Andrey SalomatIn / Pedal Markt

Title: Demod

Rev: v1rev1

Sheet: /Peak Detector/
File: peak.kicad_sch

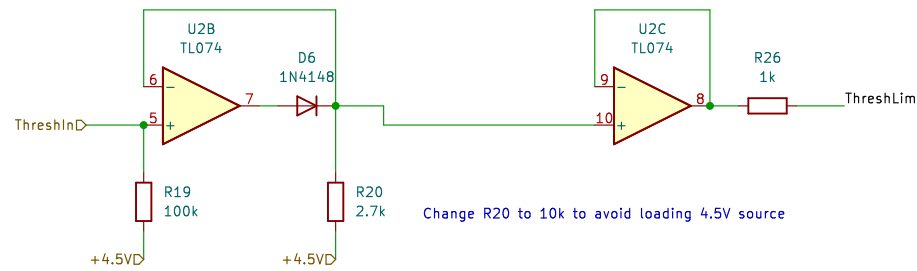
Change U2 to R2R opamp due to phase reversal issue

Change R20 to 10k to avoid loading 4.5V source
